Certificate of Appropriateness

Property 2245 N. Lake Dr. North Point South
Description of work Construct new detached garage at the rear of the property. Garage will be clad in Cedar clapboard with a max. 5 ½” reveal.
Date issued 10/10/2019 PTS ID 114833 COA: new garage

FRONT ELEVATION

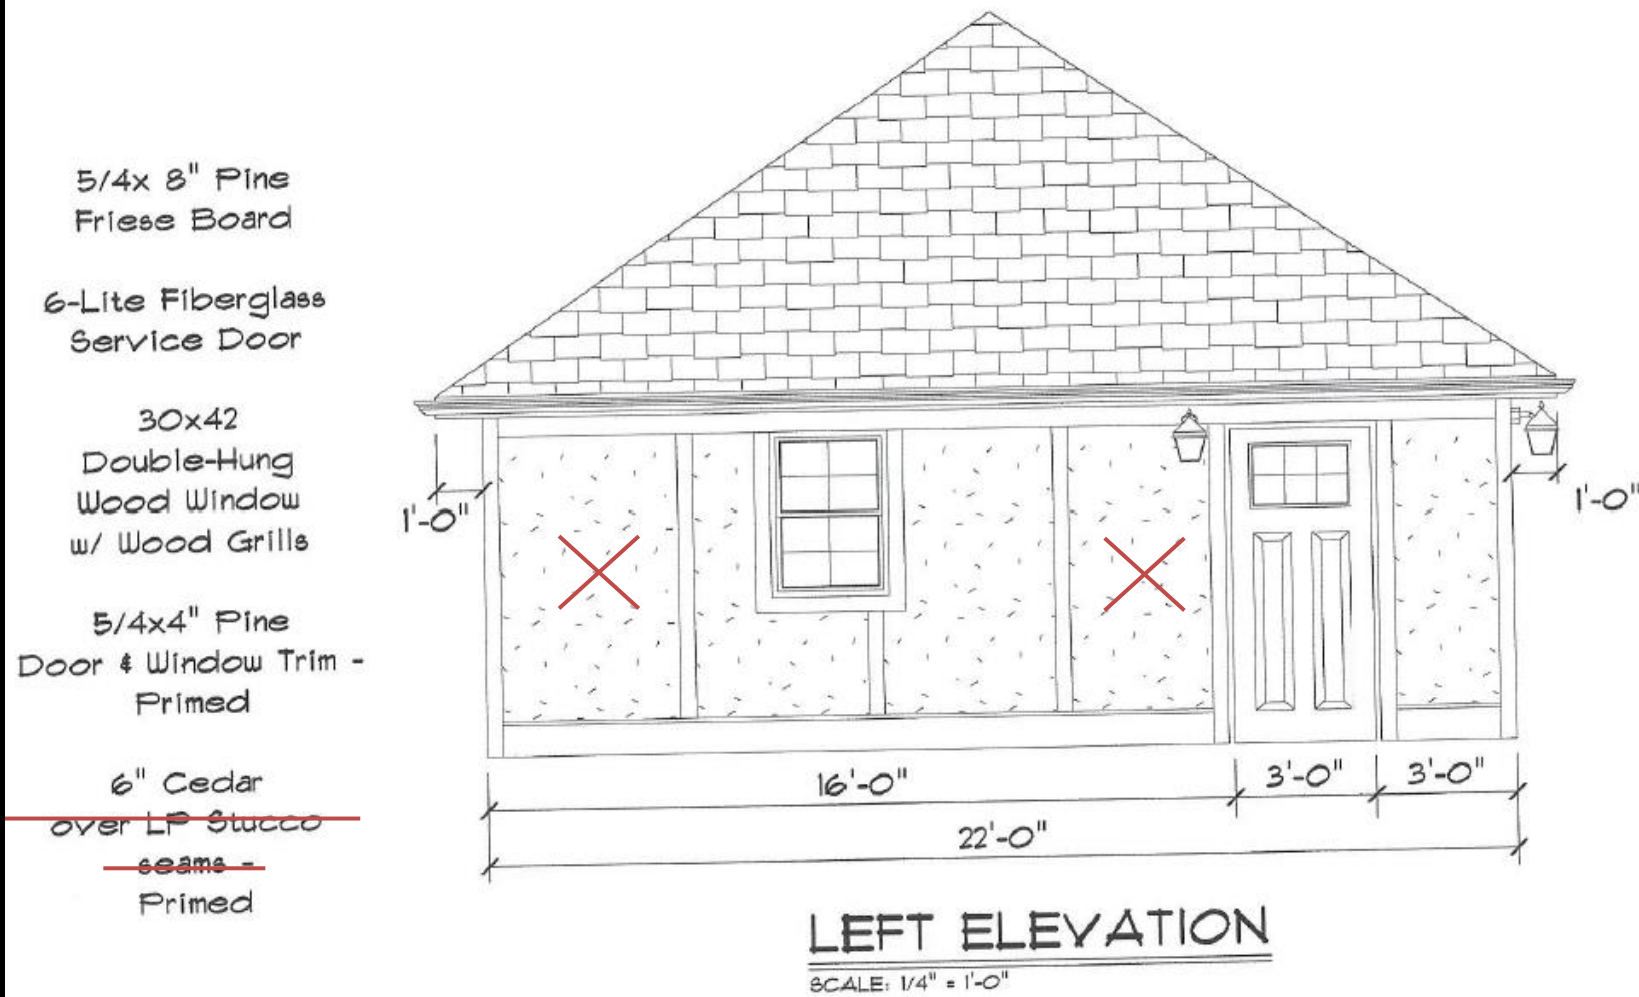
LP Stucco Panels are NOT appropriate, Cedar clapboard with a maximum 5 1/2" reveal will be utilized

Per SHPO, overhead door MUST have a solid color appearance and NOT simulate stained wood – see attached letter

Proposed left (South) elevation

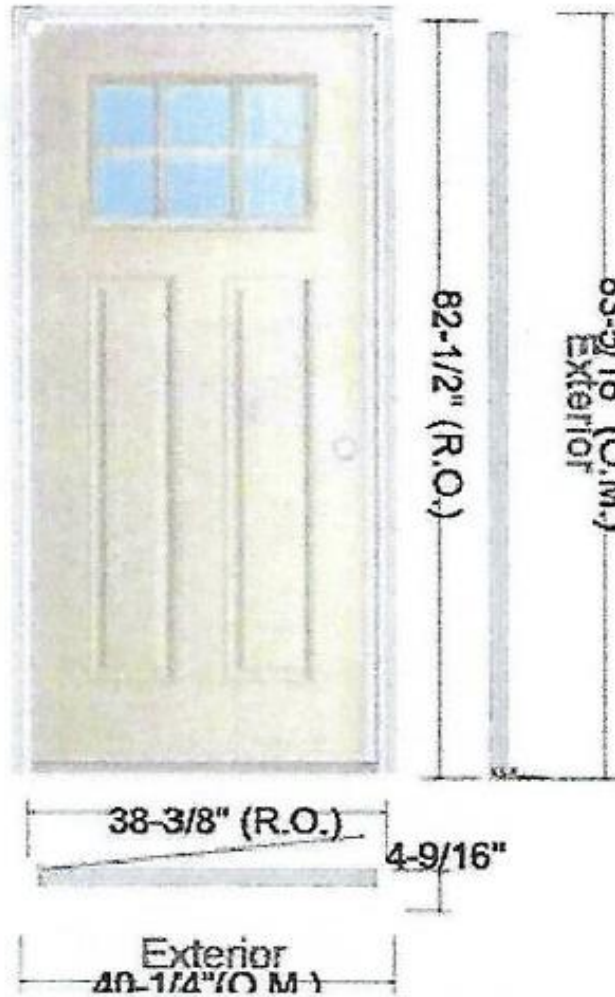
LP Stucco Panels are NOT appropriate, Cedar clapboard with a maximum 5 1/2" reveal will be utilized

Per SHPO, door MUST have a solid color appearance and NOT simulate stained wood – see attached letter

Proposed right (North) and rear (West) elevations

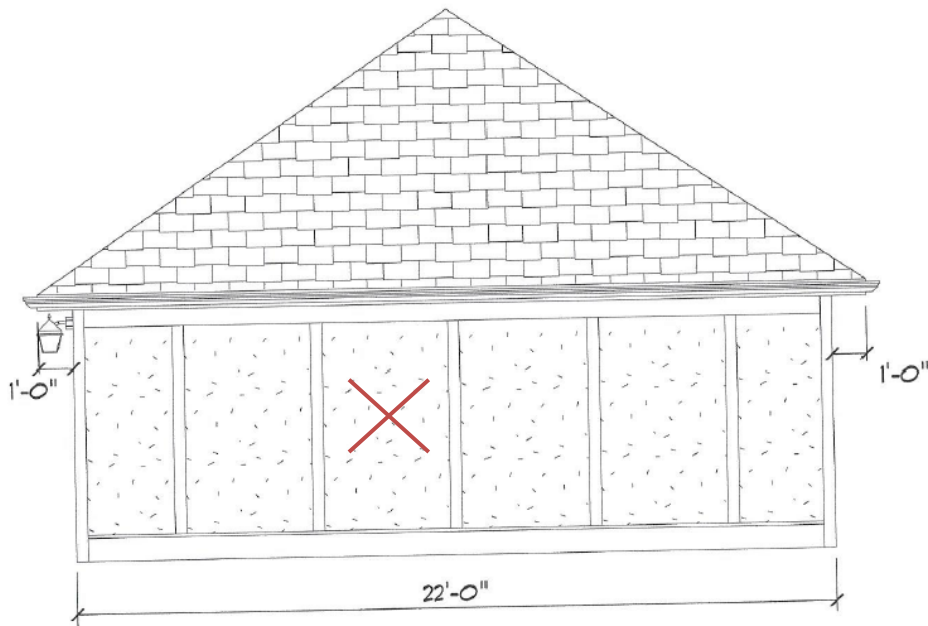
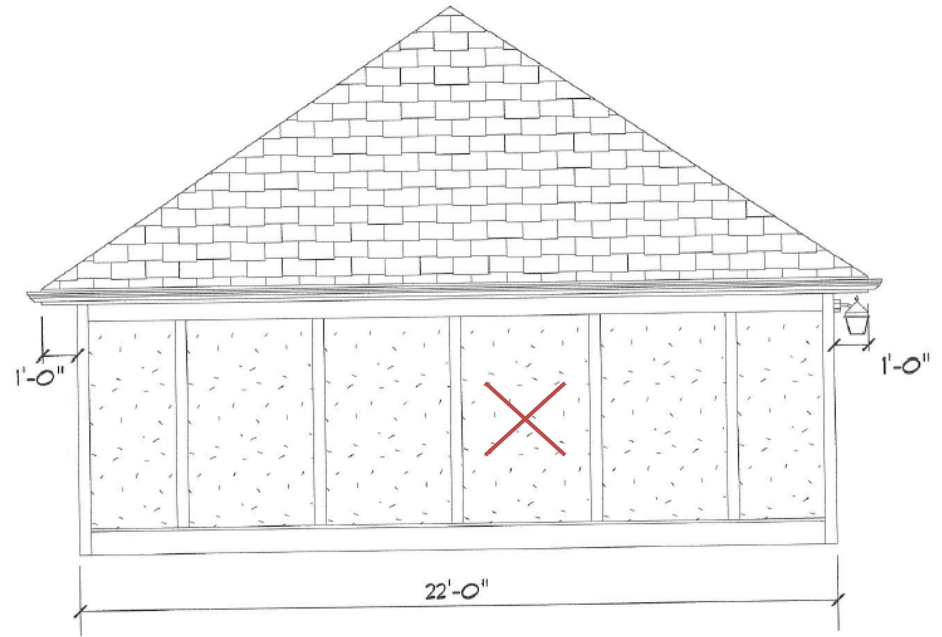
LP Stucco Panels are NOT appropriate, Cedar clapboard with a maximum 5 1/2" reveal will be utilized
